AGENDA

MATANUSKA-SUSITNA BOROUGH

PLATTING BOARD MEETING

May 1, 2025

Bella Ridge Master Plan
Useable Area, Roads, Drainage & Topo Map

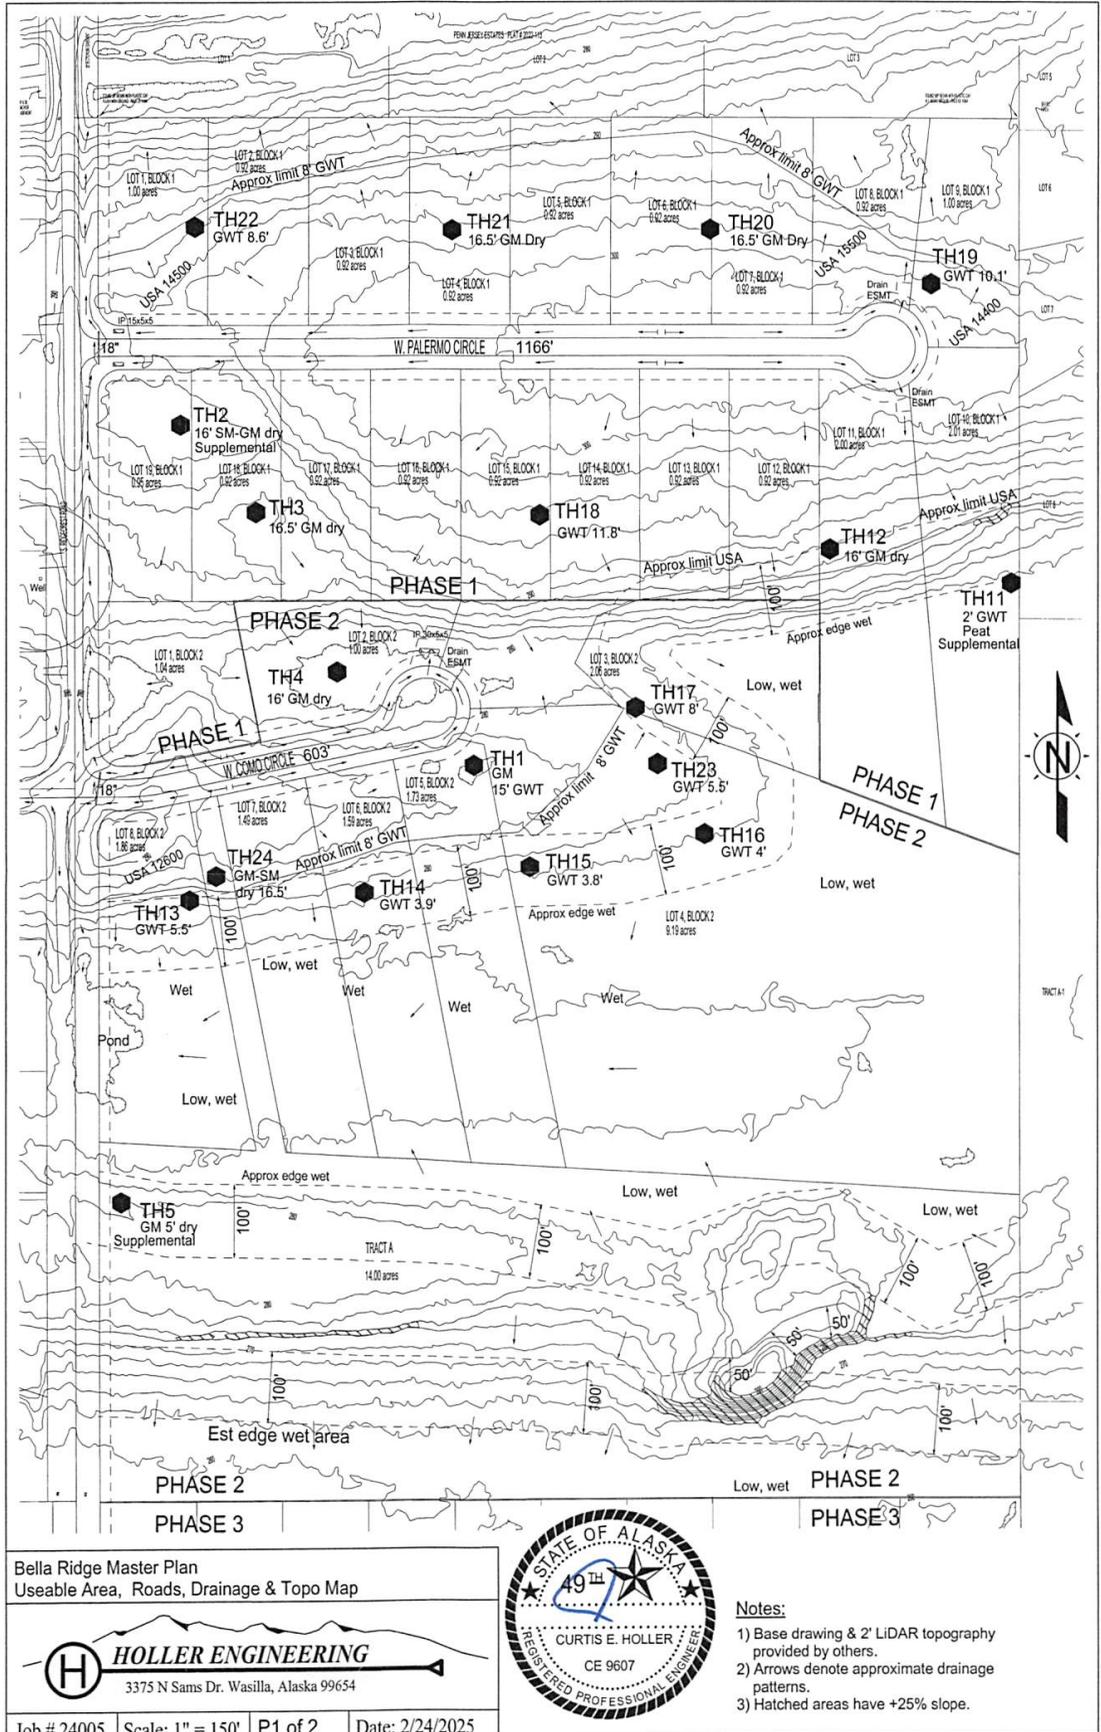
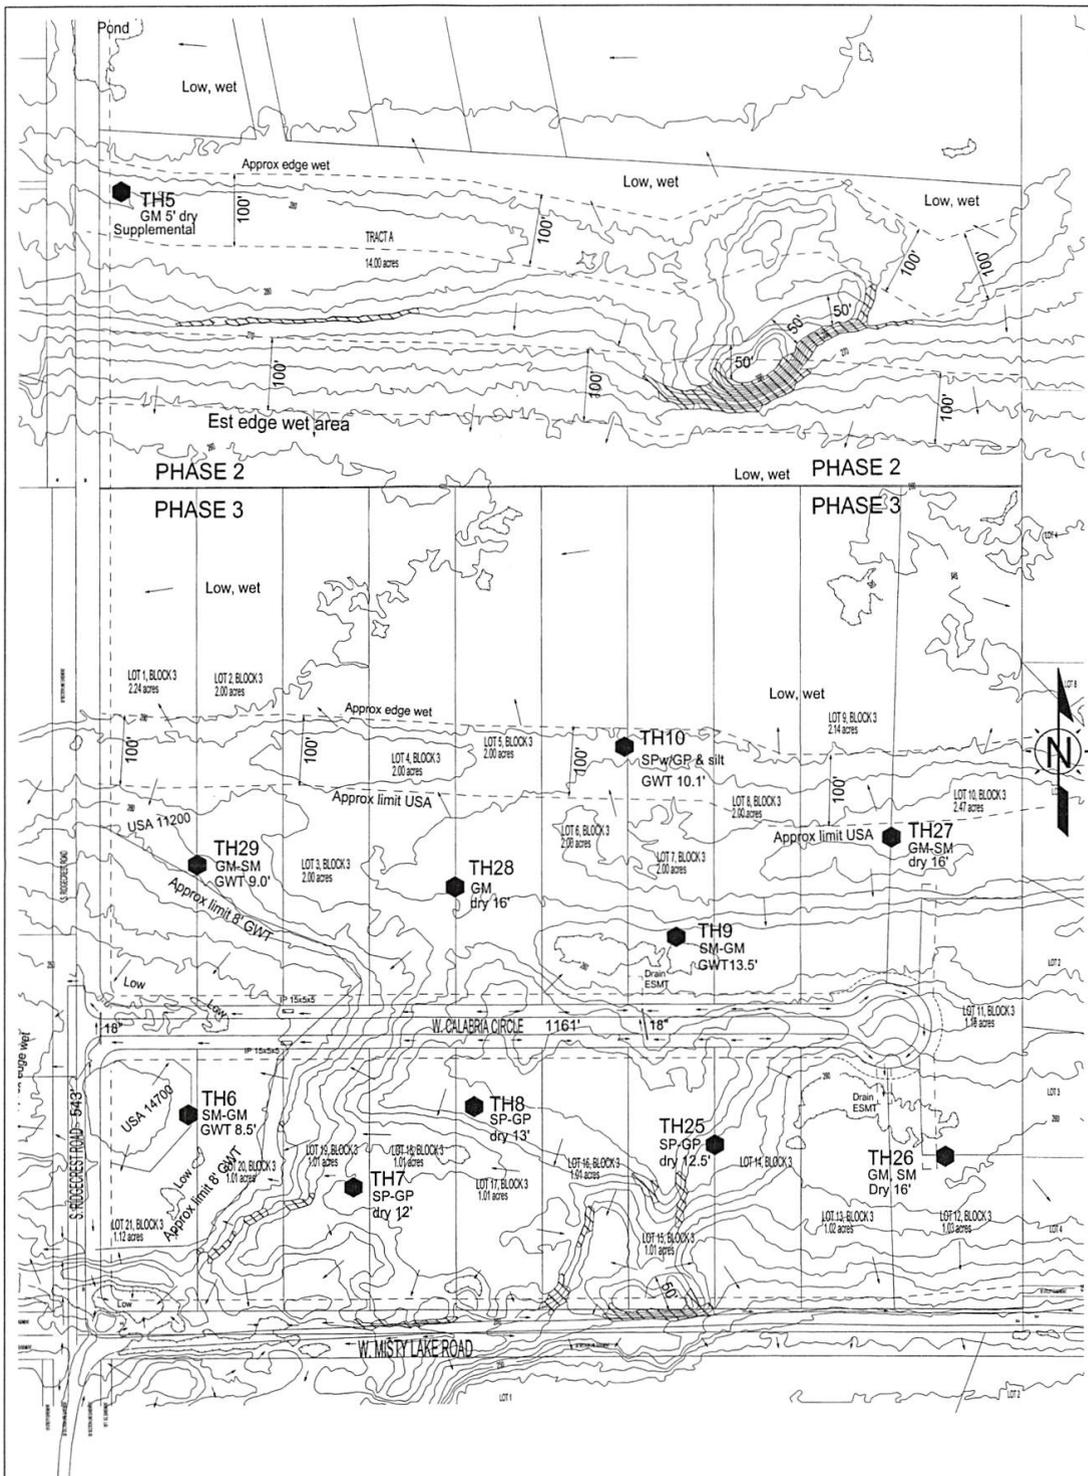
*Platting staff notes that a revised soils report will need to be submitted prior to the recordation of Phase 3, or the non-conforming lots noted as Lot 1, 2, & 21, Block 3 will need to be combined with lots that currently meet the minimum useable area requirements (**Recommendation #6**).*

5. Redesign the flag pole portion of Tract A to be a minimum of 60' wide per MSB 43.20.300(E)(6).
6. Provide a Revised soils report certifying Lots 1, 2, & 21, Block 3 have the required usable area prior to the recordation of Phase 3. Alternatively, these lots can be absorbed into adjacent proposed lots that currently meet the usable area requirements.

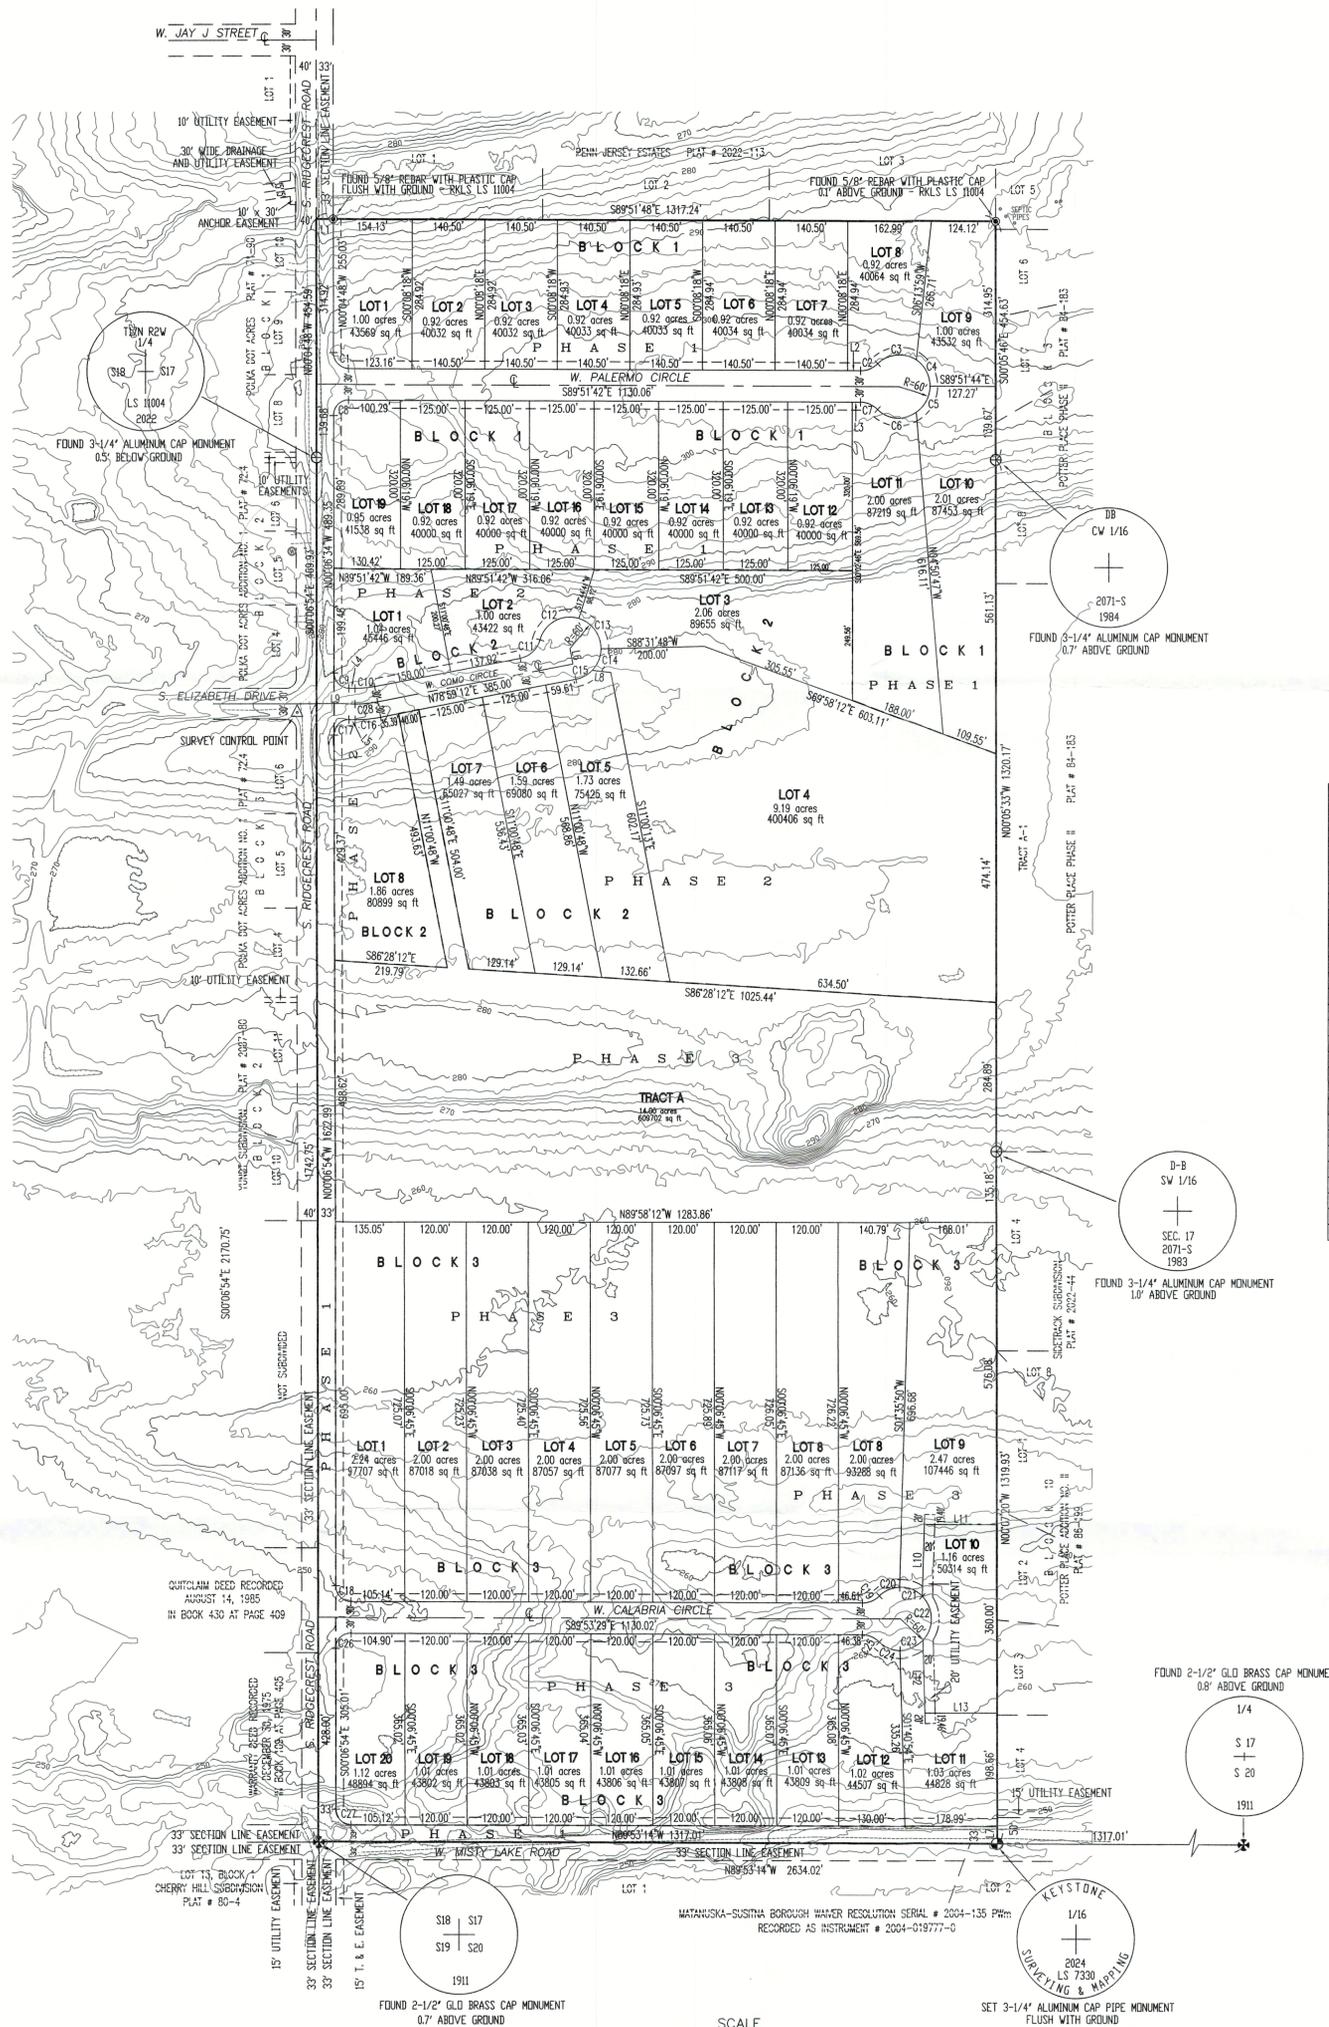
Comment regarding Tract A still stands: Redesign the pole portion of Tract A so that it is a minimum of 60' wide.

- A. The agenda plat shows one fewer lots in Block 3 than the RFC packet. We prefer fewer lots to mitigate some concerns about wetlands, septic systems, wells, and setbacks.
- B. Well and septic overlaps between lots will be an issue. Increasing the lot sizes would resolve this concern.
- C. Does the petitioner plan to construct Ridgecrest all the way through the whole west side? It is difficult to tell. There are significant wet areas that will make future maintenance more difficult. The membership recommends building the full length of Ridgecrest for future development and connectivity.
- D. We would like to see construction of Mist Lake Road through to Ridgecrest Road for future development and connectivity.

Thank you for passing this along. I believe the yellowing markings (attached), are supposed to be utility easements. It's a little tough to decipher and how wide. MTA would like to comment/request the dedicated utility easements are both marked clearly and have their dimensions easy to identify.
